To: Planning Commission
From: Urban Design Committee
Date: July 16, 2018
RE: **Final Location, Character, and Extent Review of modifications to Hull Street, from Chippenham Parkway to Arizona Drive; UDC 2018-28**

The application is for final location, character, and extent review of modifications to Hull Street, from Chippenham Parkway to Arizona Drive.

Typical section proposed in the Hull Street Corridor Revitalization Plan (page 97)

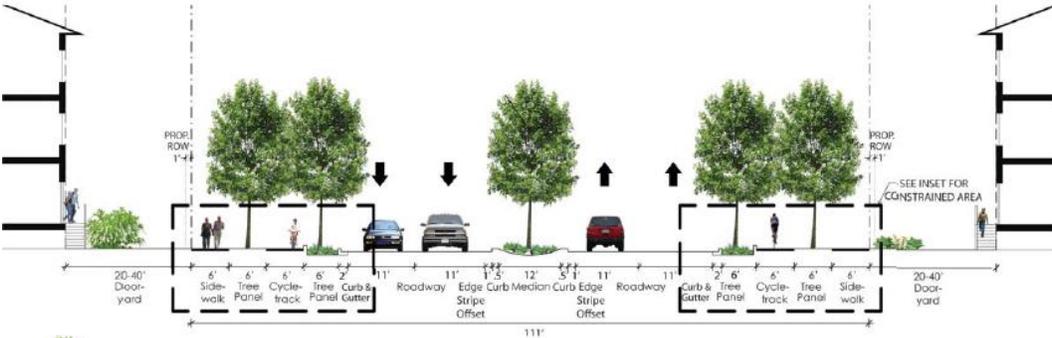
The proposed typical section includes: a continuous pedestrian sidewalk network and crossings; a separated cycle track/bicycle way on each side of the corridor; a landscaped buffer between pedestrians and bicycle way and travel way that provides sufficient space for comfortable and furnished transit stops and amenities; a landscaped median that provides accommodation of left turn lanes

at intersections to reduce rear end and rear-angle crashes; and provide safe pedestrian crossings with a minimum 6' pedestrian refuge even when the median is reduced to provide a left turn pocket; two travel lanes in each direction to maintain vehicular capacity and operation; and a gutter pan that can channelize water into low impact development (LID) features in the planting buffer (page 97).
